E/ECE/324
E/ECE/TRANS/505 } Rev.2/Add.100/Amend.1

Addendum 100: Regulation No. 101

Amendment 1

UNIFORM PROVISIONS CONCERNING THE APPROVAL OF PASSENGER CARS EQUIPPED WITH AN INTERNAL COMBUSTION ENGINE WITH REGARD TO THE MEASUREMENT OF THE EMISSION OF CARBON DIOXIDE AND FUEL CONSUMPTION AND OF CATEGORIES M1 AND N1 VEHICLES EQUIPPED WITH AN ELECTRIC POWER TRAIN WITH REGARD TO THE MEASUREMENT OF ELECTRIC ENERGY CONSUMPTION AND RANGE

Figure 1
Test sequence - M1 and N1 categories of vehicles

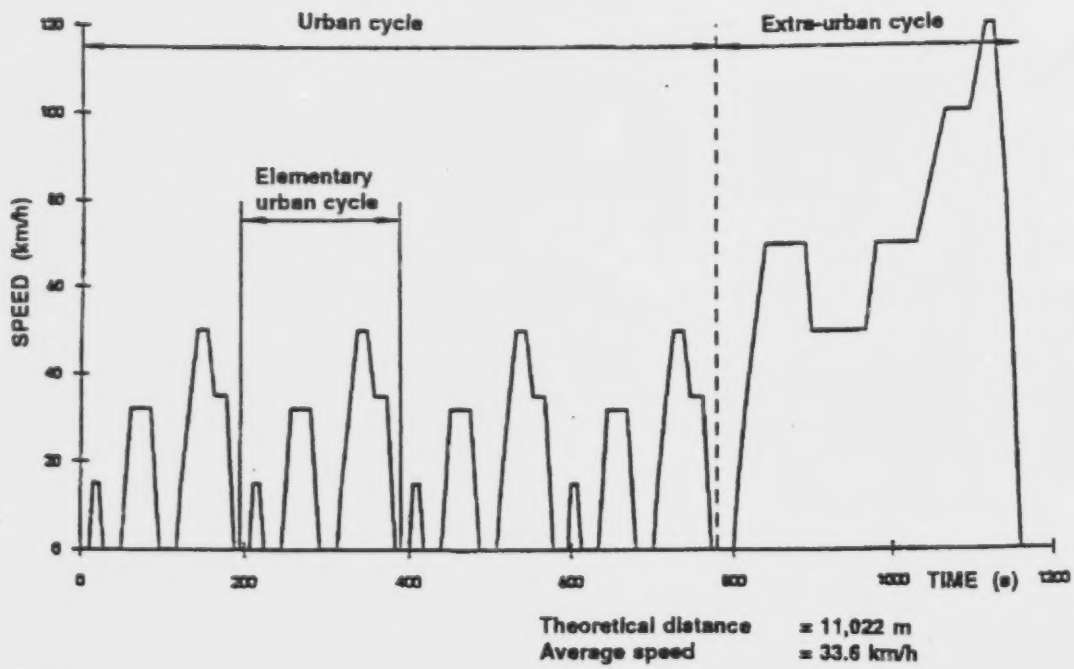
Insert a new annex 6, to read:

The test sequence is composed of two parts (see figure 1):

(a) an urban cycle made of four elementary urban cycles;
(b) an extra-urban cycle.

Figure 2

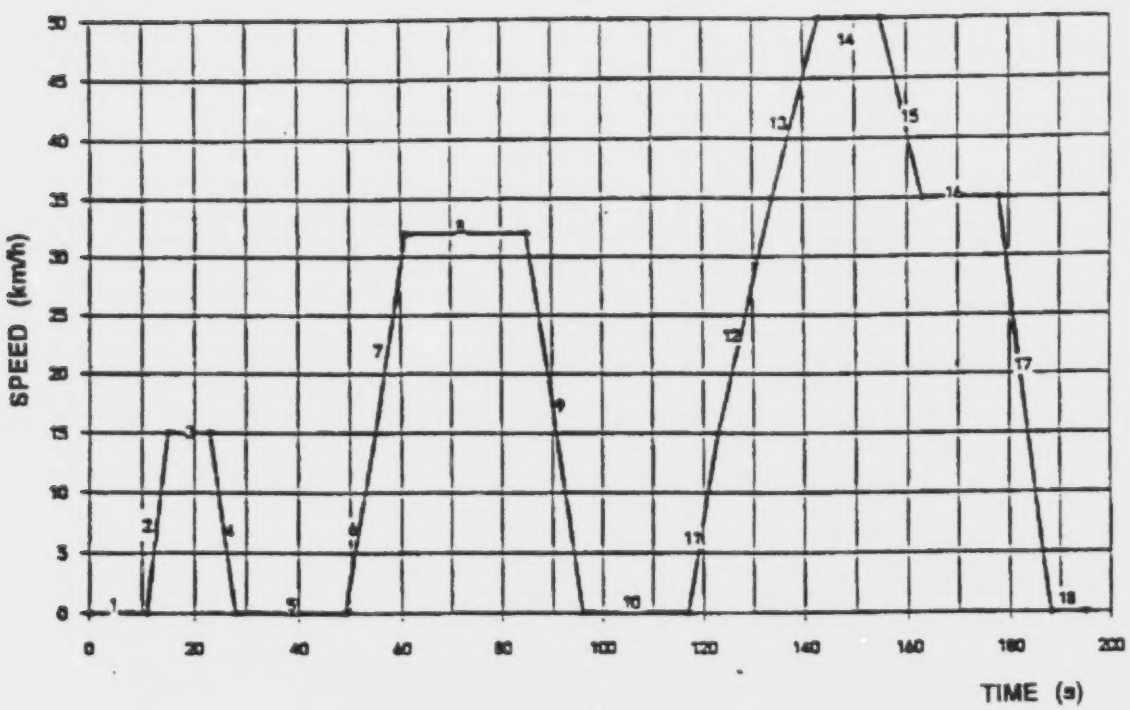
The urban cycle is composed of four elementary cycles of 195 seconds each and lasts 780 seconds in total.

Description of the elementary urban cycle is given in figure 2 and table 1.

Figure 3
Extra-urban cycle (400 seconds)

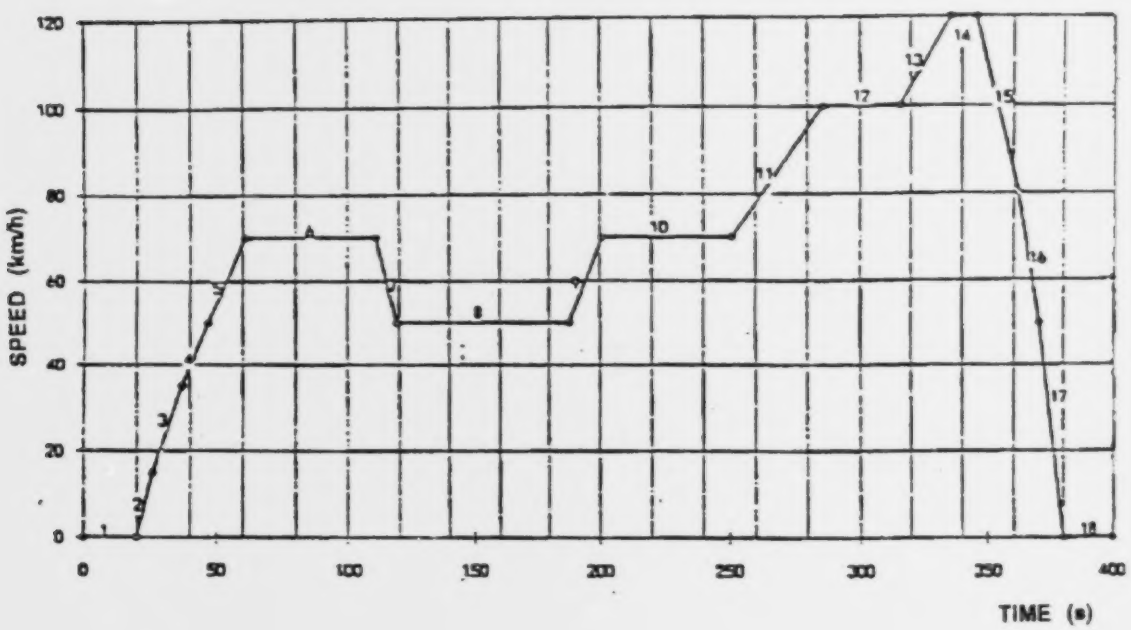
The description of the extra-urban cycle is given in figure 3 and table 2.

Note: The procedure to be adopted when the vehicle failed to meet the speed requirements of this curve is detailed in item 1.4.

Figure 4

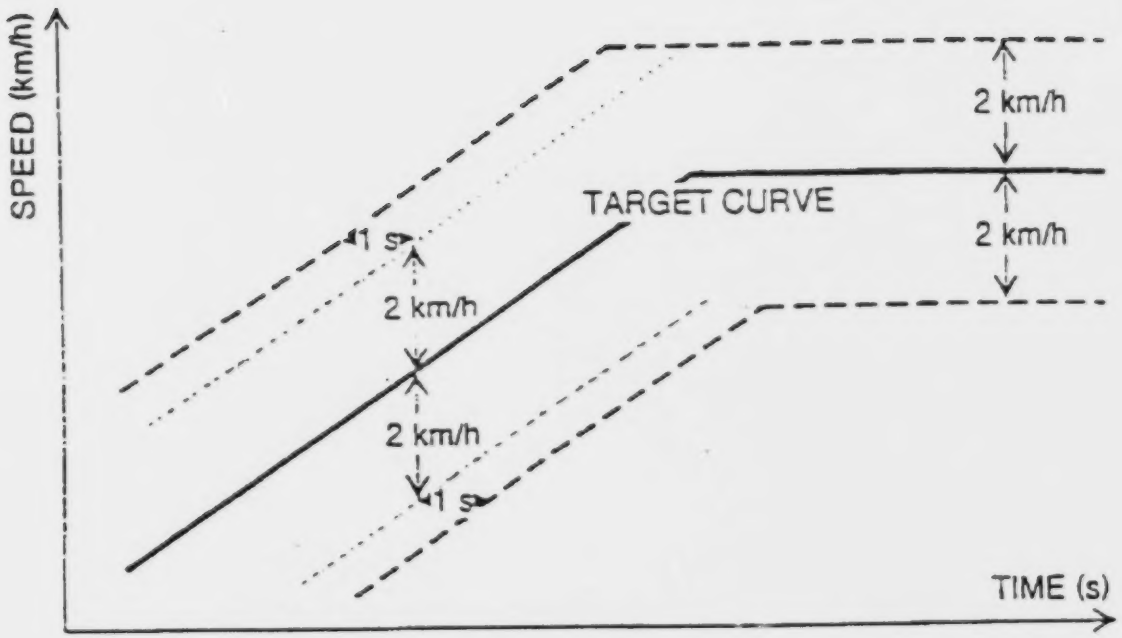
Tolerances on speed (± 2 km/h) and on time (± 1 s) are geometrically combined at each point as represented in figure 4.

Below 50 km/h, deviations beyond this tolerance are permitted as follows:

(a) at gear changes for a duration less than 5 seconds,
(b) and up to five times per hour at other times, for a duration less than 5 seconds each.
